RE: Summit Eden Phase 1C

The following are comments and responses pertaining to the civil engineering plans from your review and received on June 06, 2014.

SUMMIT EDEN PHASE 1C

ROADWAY AND UTILITY CONSTRUCTION DRAWINGS

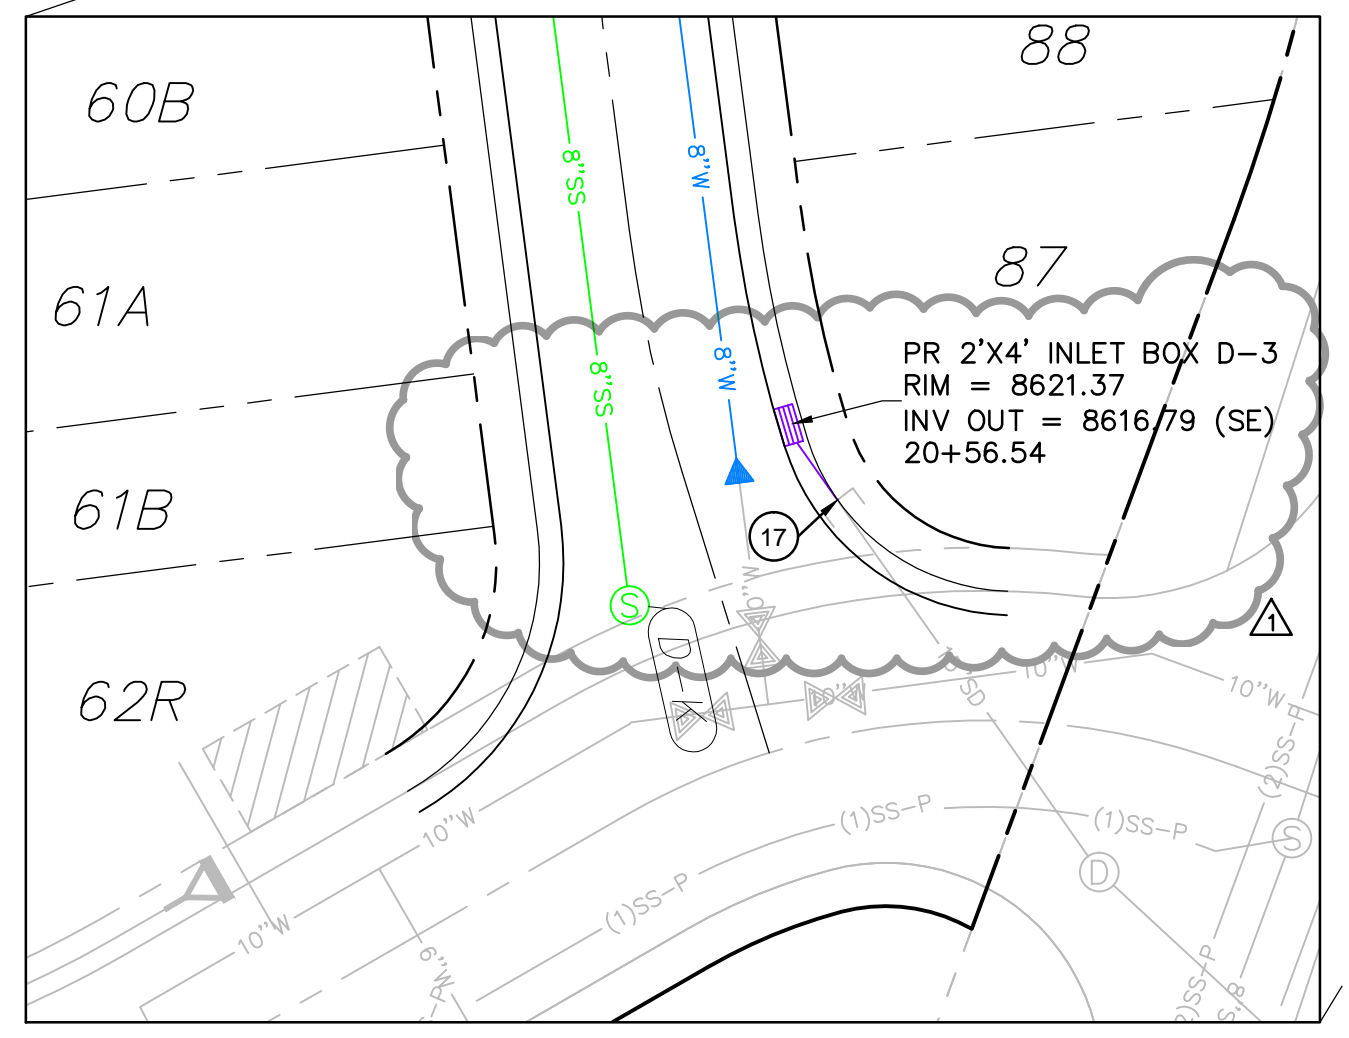
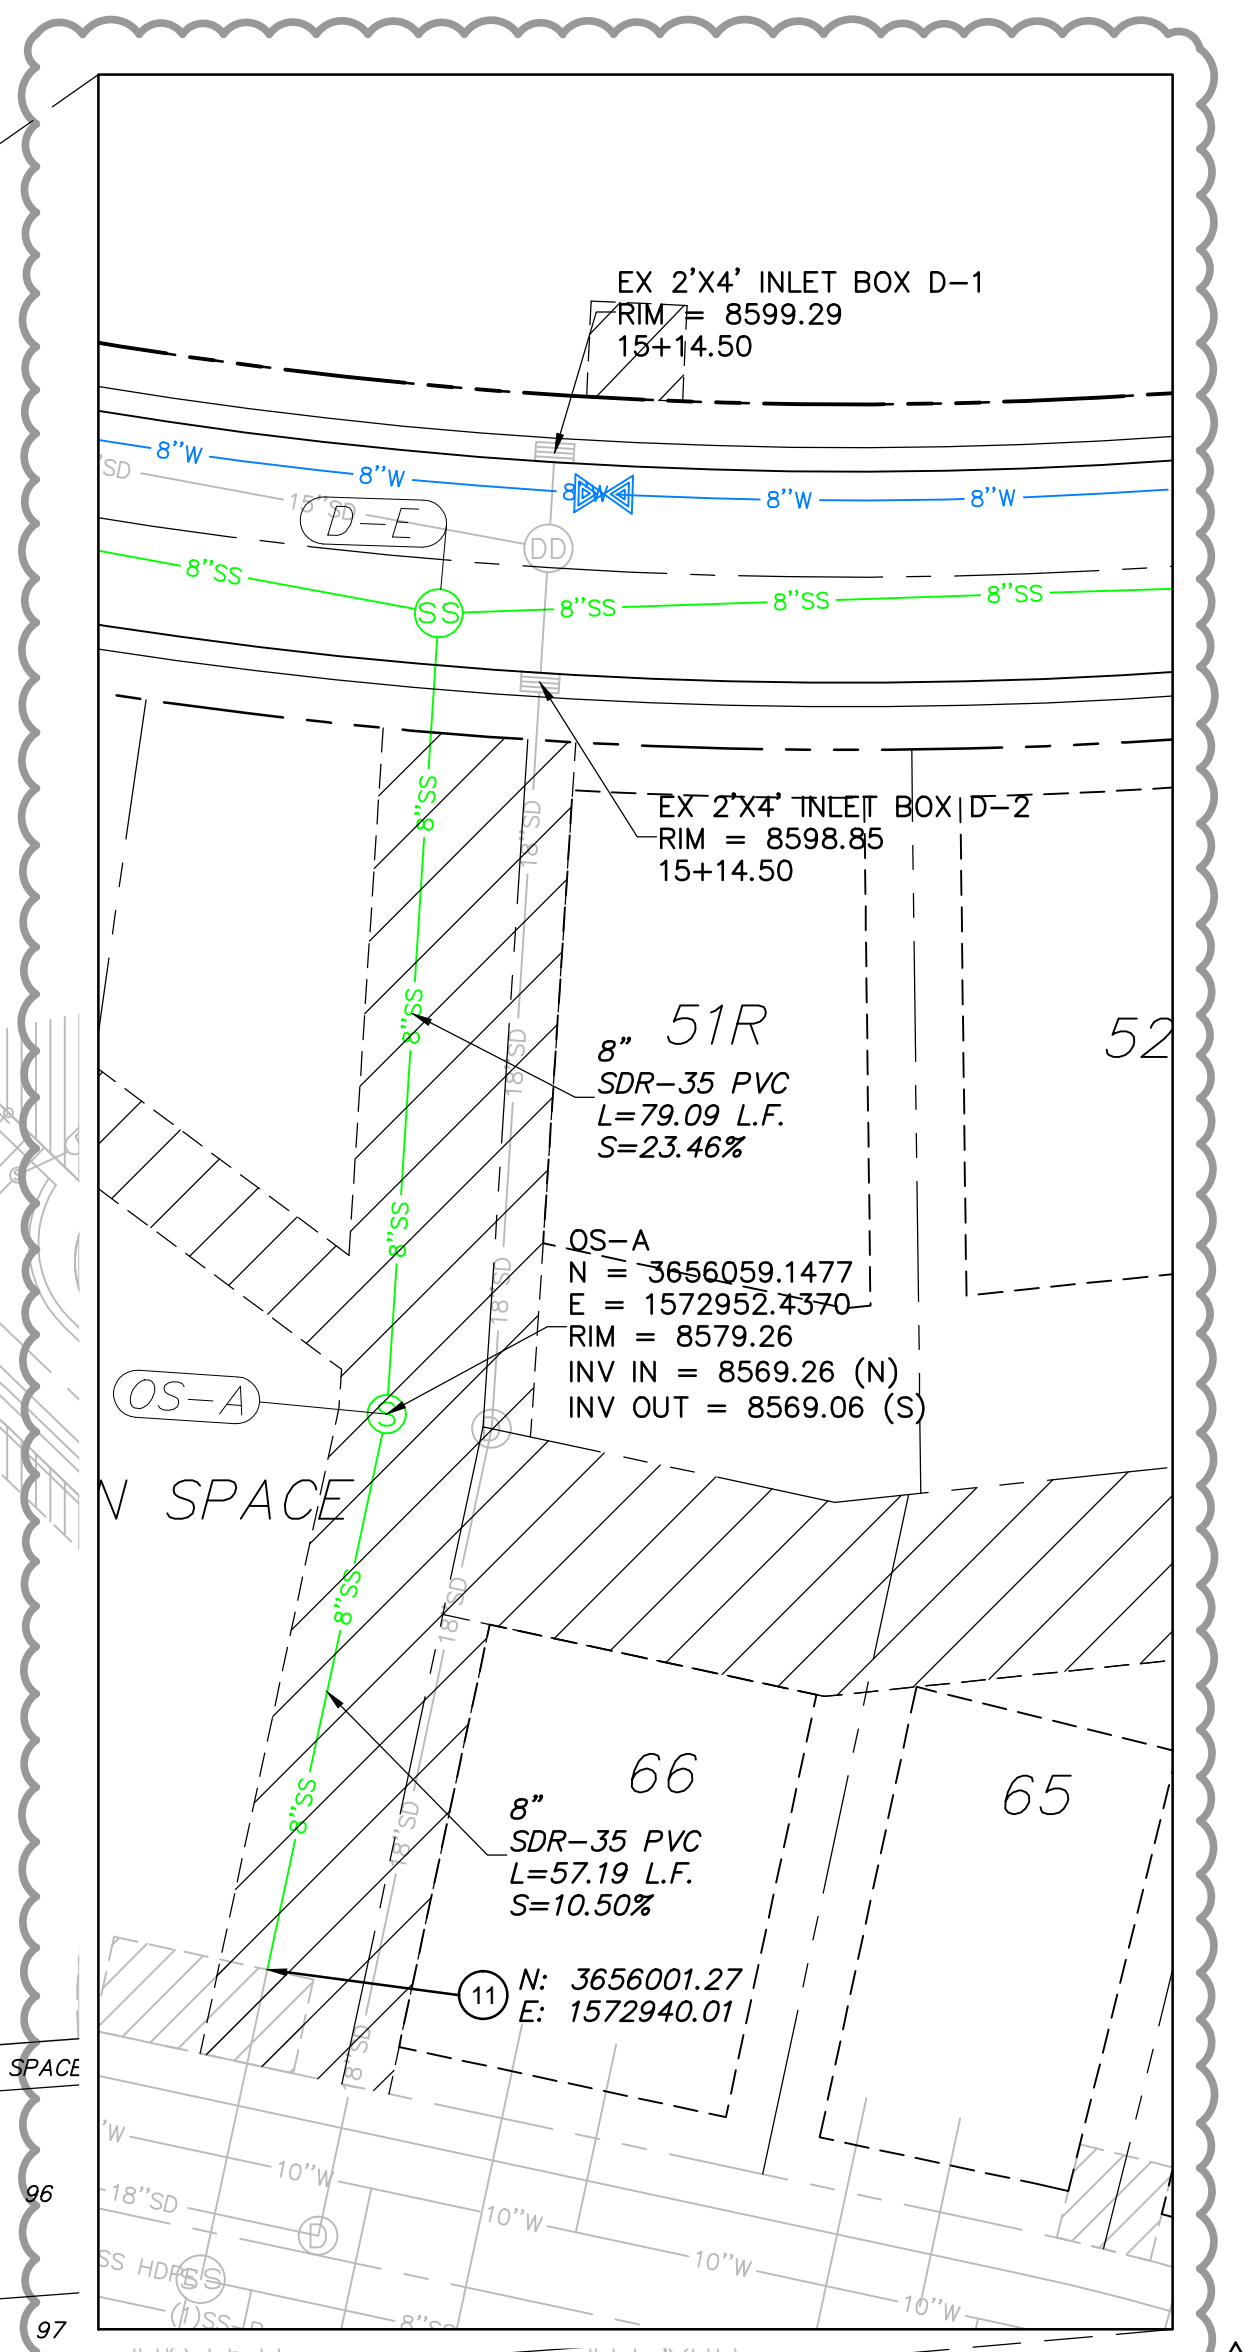
2. Sheet 1.01 - Why did the water service size change from 3/4" to 2"? Seems very large for residential service.

3. Sheet 1.01 - Why did the sewer service size change from standard to 6"? Seems very large for residential service.

Response: In home sprinkler demand, experience, and vendor recommendation.

Response: The laterals have been changed back to 4".

SHEET NUMBER
1.02

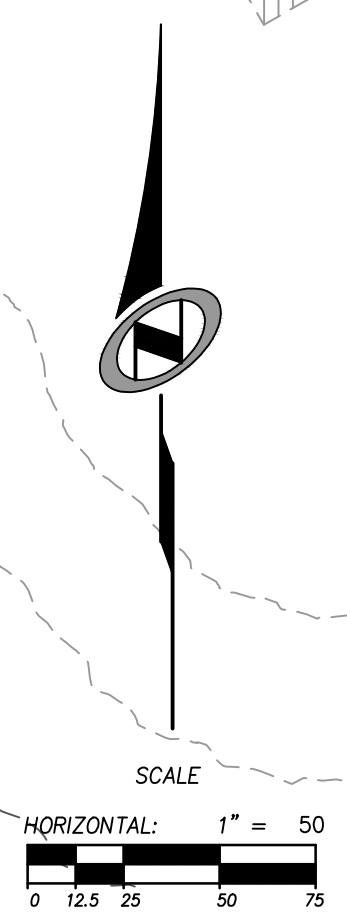
4. Sheet 1.02 - Why has the water main size changed? Is this in the master plan approved by DDW?

5. Sheet 1.02 - Design of dry utilities?

6. Sheet 1.02/1.03 - Easement needed for SD/SS through open space. (open space vs PUE)

Response: To avoid stagnation within the line

Response: Dry utilities has been added to plans.

Response: Owner is working with Weber County to secure necessary easements.

SHEET NUMBER
1.03

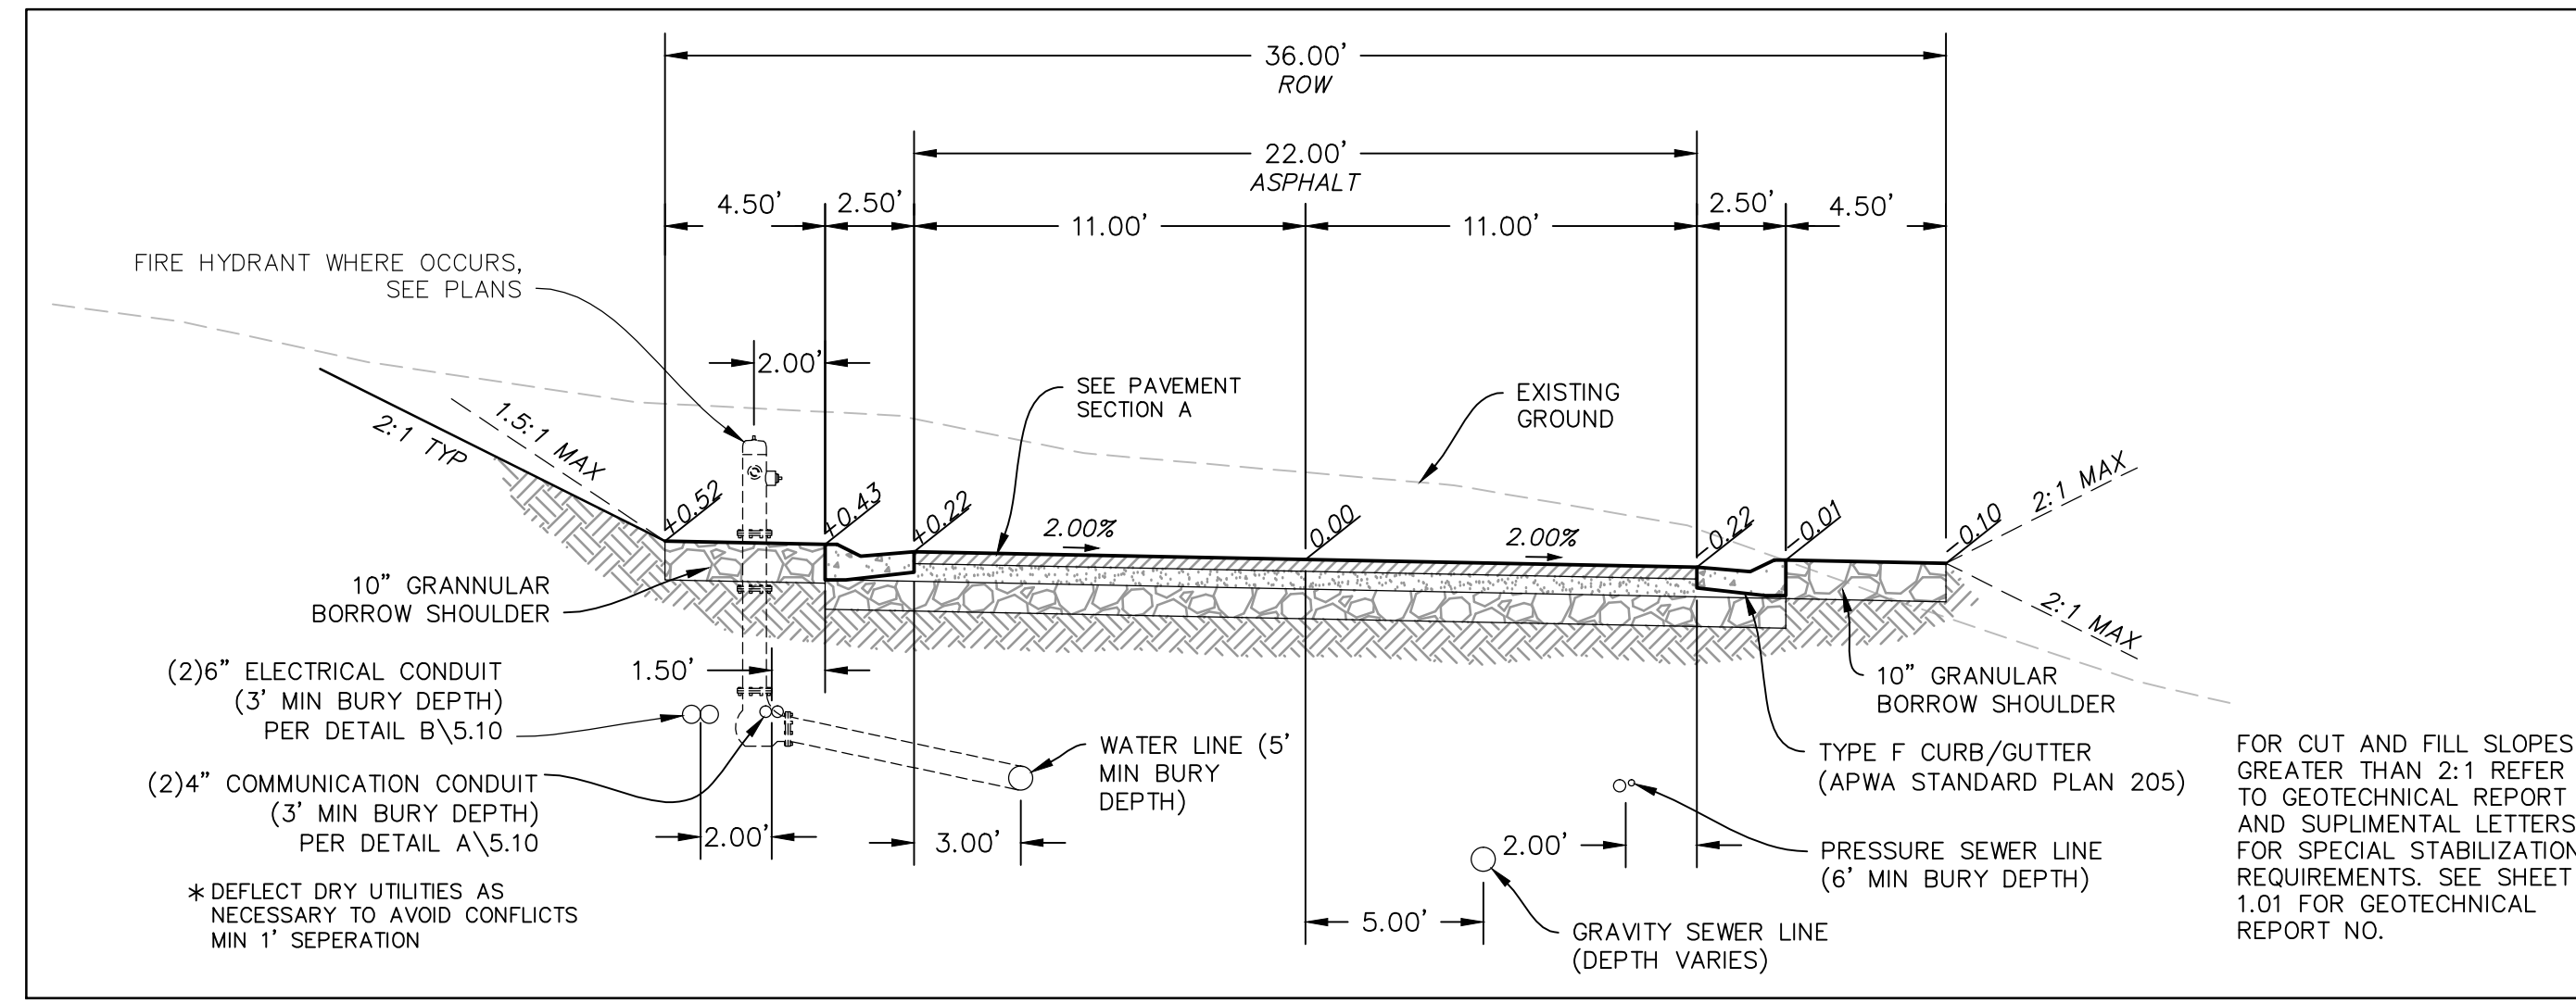
7. Sheet 1.03 - Slope easement required on unplatted land north of road.

8. Sheet 1.03 - Did subdrain move? If so, revised easement required.

9. Sheet 1.03 - Appears SD in Summit Pass and through unplatted land has been revised to tie into revised SD on Copper Crest. Revised sheets for Summit Pass project required. Revised easement for unplatted land required. (REV 16)

10. Sheet 1.03 - SD/SS easement note refers to plat - are you planning on filling a revised plat? If not, please remove reference.

Response: Easement is shown on the design plans, and easement document is being drafted and will be submitted shortly.

*Response: Subdrain moved slightly due to revised grading. New easement is not required. Plat note #28 identifies a 10-foot wide slope drain easement, 5 feet on each side of the **as-constructed pipe alignment, in the approximate location as shown hereon.***

Response: Revised sheets have been submitted. Owner is working with Weber County to secure necessary easements.

Response: removed reference to plat

SHEET NUMBER
2.00

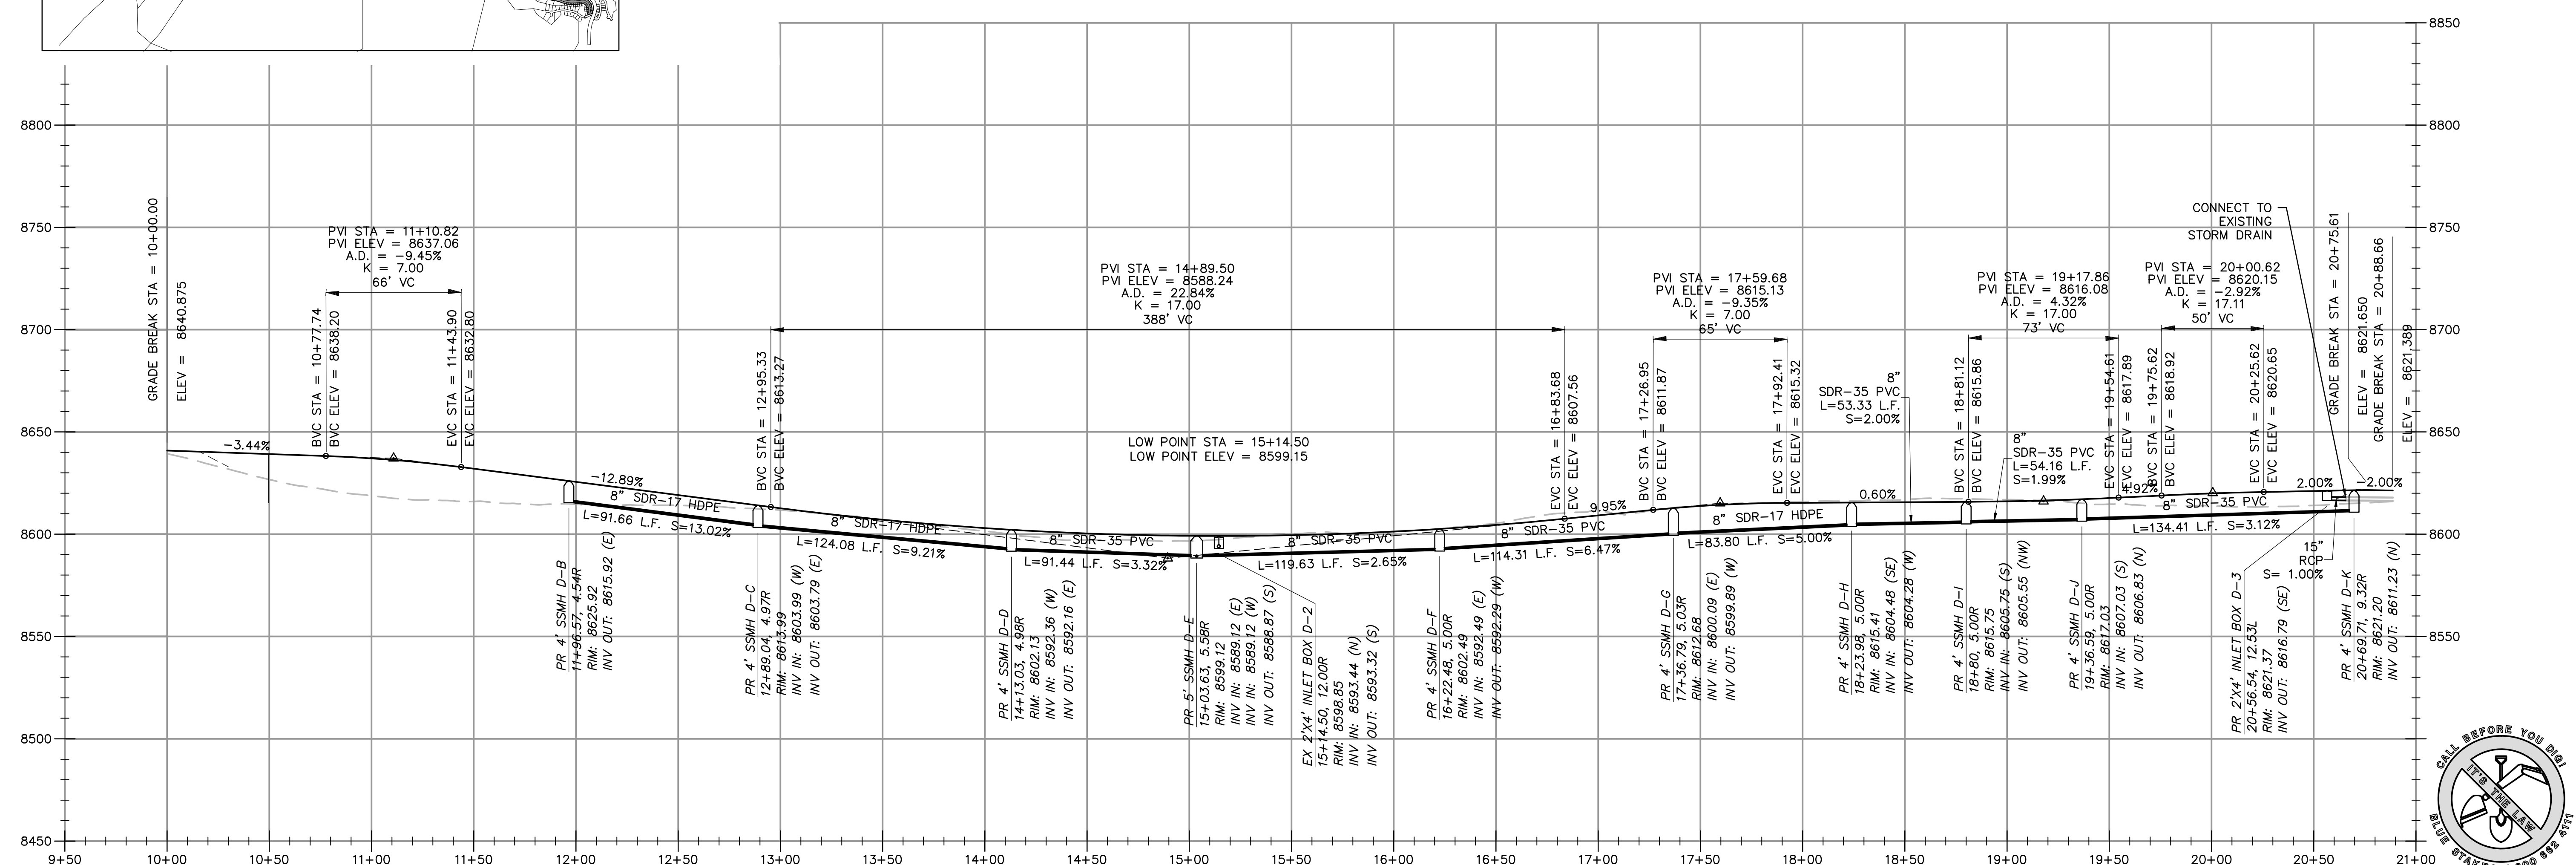
11. Sheet 2.00 - Fire department approval for road grade of 12.89%?

12. Sheet 2.00 - Sewer lateral through open space requires an easement, or route lateral to Copper Crest.

Response: 13% has been approved by Fire Marshall

Response: Owner is working with Weber County to secure necessary easements.
